# 1979 Corvette: Service News: Corvette Auxiliary Cooling Fan Wiring Revision

**Model and Year:** 1979 Corvette Equipped with 5.7L (350 Cu. In.) V-8 RPO L82 and Air Conditioning

**Source:** Chevrolet Service News

Fig. 4 — 1979 Corvette Auxiliary Cooling Fan Wiring Diagram

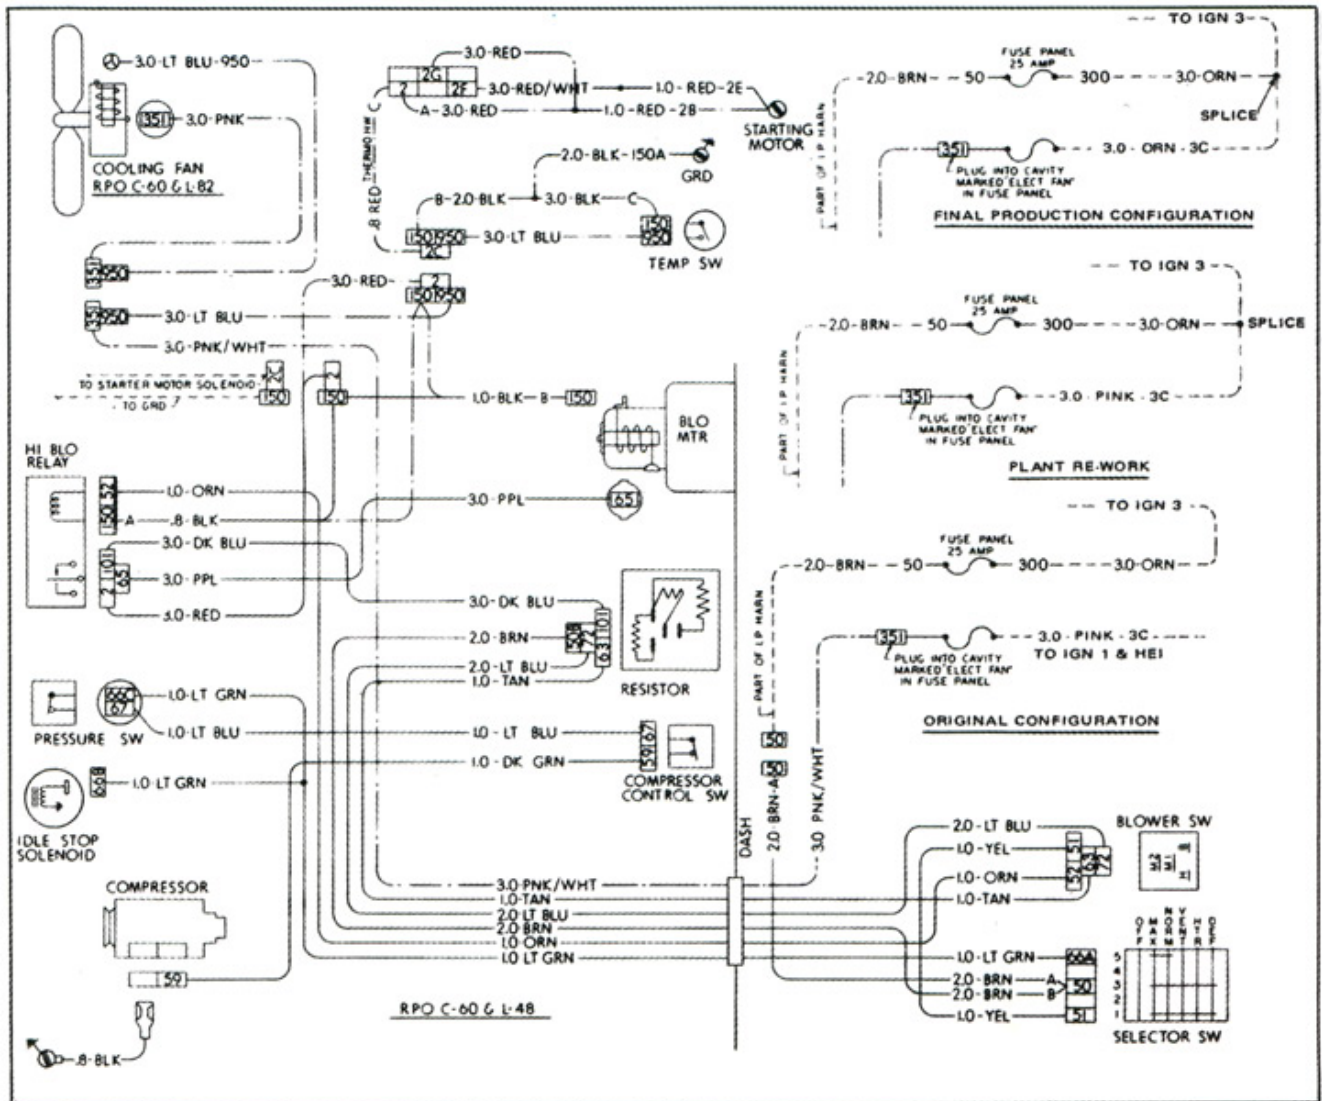
During early production, it was discovered that non-powered rundown of the fan motor generated a voltage sufficient to maintain ignition after ignition switch shut-off. This could result in a momentary engine run-on condition similar to dieseling.

To eliminate any run-on, the assembly plant began re-working the instrument panel wiring harness, effective with VIN 1Z8749S402690, as shown in the wiring diagram (see Figure 4). A final production revision to the harness (see diagram) will be phased into production as soon as possible.
